**BELLEFONTE COMBINED LICENSE APPLICATION – RESPONSE TO SAFETY
EVALUATION REPORT WITH OPEN ITEMS FOR CHAPTER 13, “CONDUCT OF
OPERATIONS”**

Reference: Letter from Stephanie Coffin (NRC) to Andrea L. Sterdis (TVA), Safety
Evaluation Report with Open Items Related to SRP Section 13 for the Bellefonte
Units 3 and 4 Combined License Application, dated September 9, 2009

Subject: Emergency Planning, Security Plan and Fitness for Duty for the Bellefonte Units 3 and 4
Combined License Application

Figure A4-8 – Radiological Sampling and Monitoring Locations

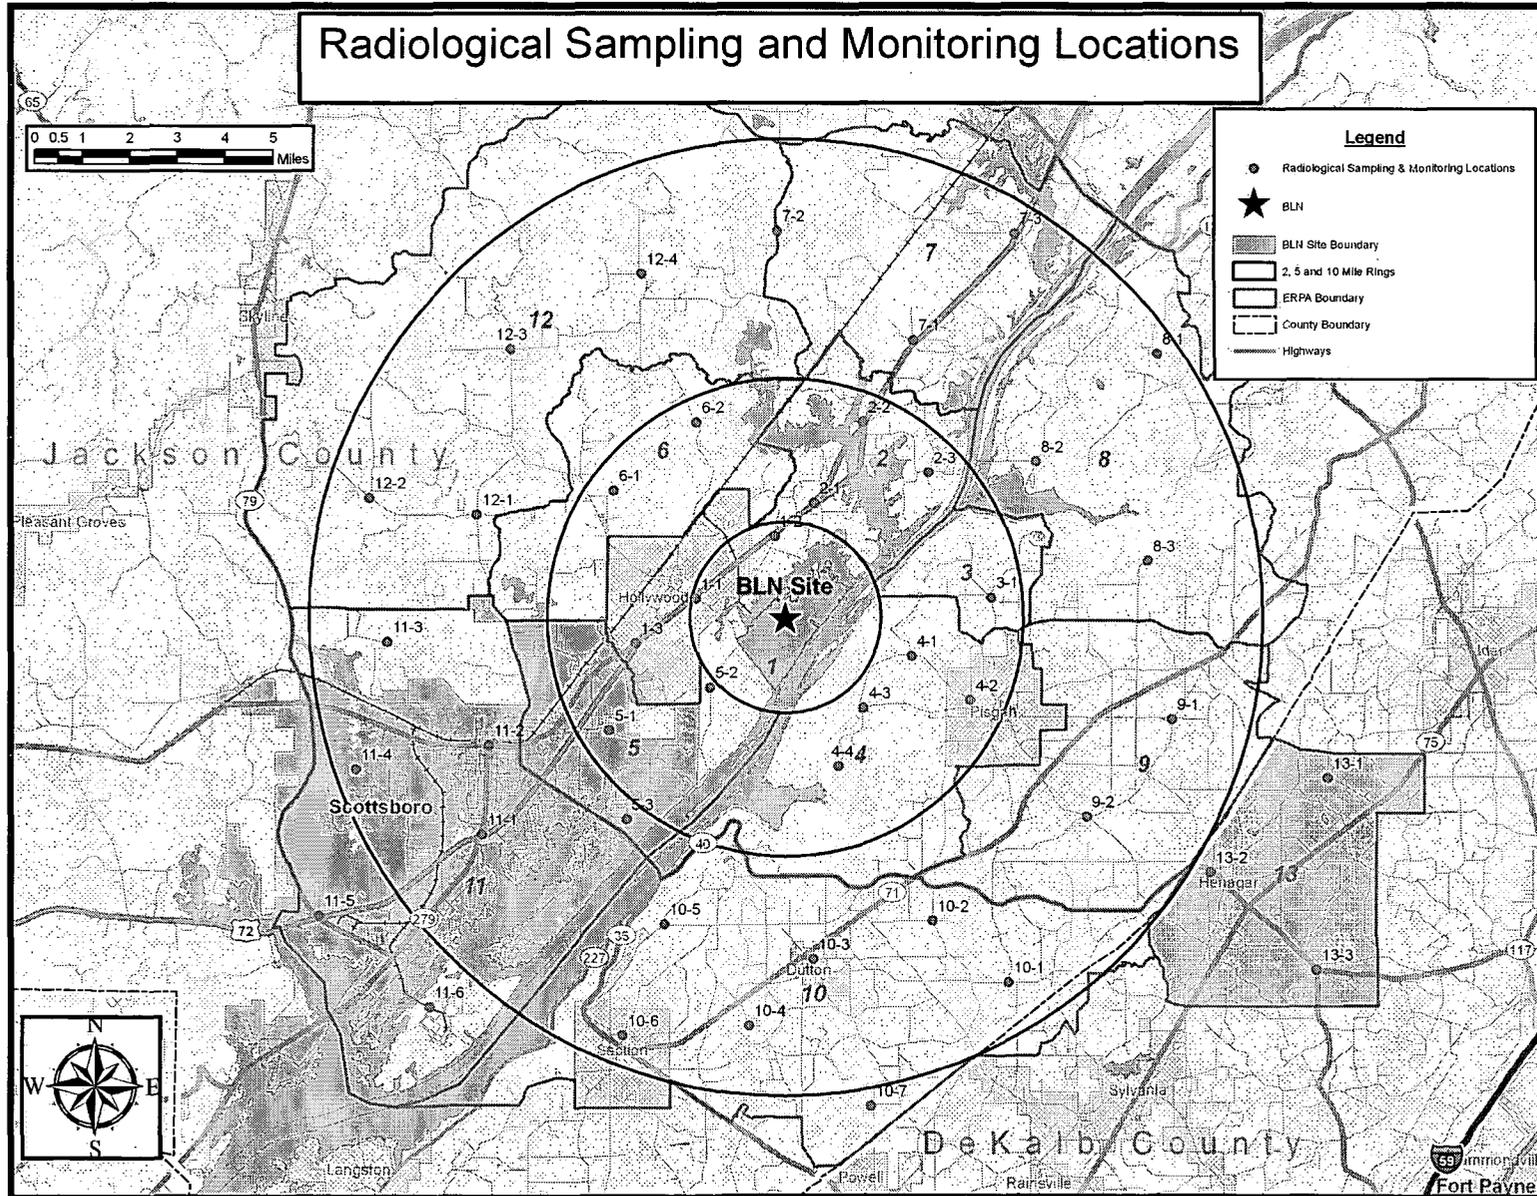
RAI 13.03-27(E) also requested a description of the pre-selected radiological sampling and monitoring point locations. In response, the applicant provided preliminary, pre-identified radiological sampling and monitoring locations on a map and a summary provided on a table attached to the RAI response. The staff created Open Item 13.3-21 to track the final descriptions of pre-selected radiological sampling and monitoring point locations in the BLN Emergency Plan.

In the October 2, 2008 response to RAI 13.03-27(E), TVA provided the preliminary, pre-identified, radiological sampling and monitoring locations on a map, and a tabular description of these locations. This information was provided as Attachments 13.03-27A and 13.03-27B, respectively in the October 2, 2008 response.

The figure depicting the preliminary, pre-selected radiological sampling points, included in the response to RAI 13.03-027(E), has been revised to remove the phrase "preliminary – subject to change." This figure and Appendix 4 of the Emergency Plan will be revised in a future revision of the Combined License (COL) Application to reflect the addition of the map as Figure A4-8 and the tabular description as Table A4-4.

COLA Part 5, Emergency Plan, Appendix 4 will be revised to include new Figure A4-8 and new Table A4-4 as follows:
